Access Compliance Report

Public Rights-of-Way

(Curb Ramps)

Intersection ID: 10012530	Main Street: CARLEEN_WAY_DR	Cross Street: N/A	Location: SE
ADA ID: F3A5BDDA8C0A	Ramp Type: PerpDiag	Initial Pass/Fail: Fail	Overall Compliance: No
Codes/Mitigation Info/Possible Solution		Field Measurements/Component Compliance	
Severity Score: 8.75

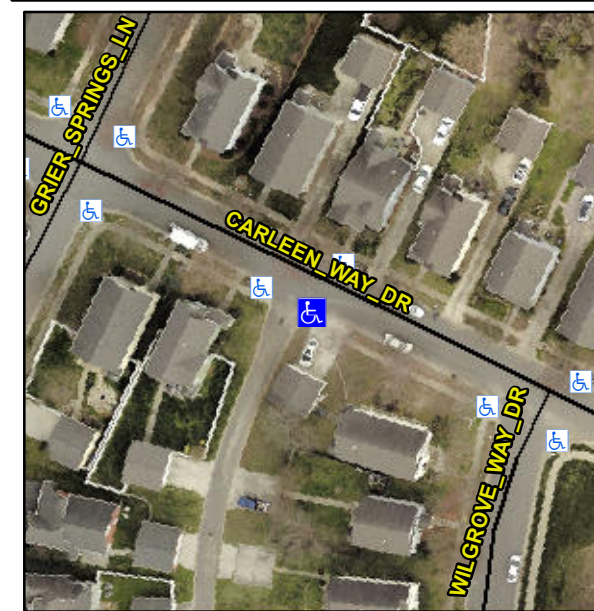
Not Found, R304.5.1

Compliance	Description	Data	Compliance	Description	Data
N/A	Ramp Length (in)	22.5	Yes	Ramp Slope (%)	8.1
No	Ramp Width (in)	44.5	Yes	Ramp XSlope (%)	0.2
N/A	Flare Type LT	N/A	N/A	Flare Type RT	N/A
N/A	Flare Slope LT (%)	N/A	N/A	Flare Slope RT (%)	N/A
N/A	Flare Traversable LT?	N/A	N/A	Flare Traversable RT?	N/A
N/A	Landing Length (in)	N/A	N/A	DWS Provided?	N/A
N/A	Landing Width (in)	N/A	N/A	DWS Contrast?	N/A
N/A	Landing Slope (%)	N/A	N/A	DWS Length (in)	N/A
N/A	Landing X Slope (%)	N/A	N/A	DWS Full Width?	N/A
N/A	Landing Curb? (Y/N)	N/A	N/A	DWS Offset (in)	N/A
N/A	Shared Landing?	N/A			
N/A	Gutter Ponding?	N/A	N/A	Gutter Slope (%)	N/A
N/A	Gutter Lip Ht (in)	N/A	N/A	Gutter X Slope (%)	N/A
N/A	Painted X Walk1?	No	N/A	Painted X Walk2?	No
	X Walk 1 Direction	To NE		X Walk 2 Direction	To NW
N/A	X Walk 1 Width (in)	N/A	N/A	X Walk 2 Width (in)	N/A
	X Walk 1 Slope (%)	4.2		X Walk 2 Slope (%)	2.0
	X Walk 1 X Slope (%)	1.3		X Walk 2 X Slope (%)	0.4

Remove & Replace Curb Ramp With Two New Directional Ramps or Equivalent.
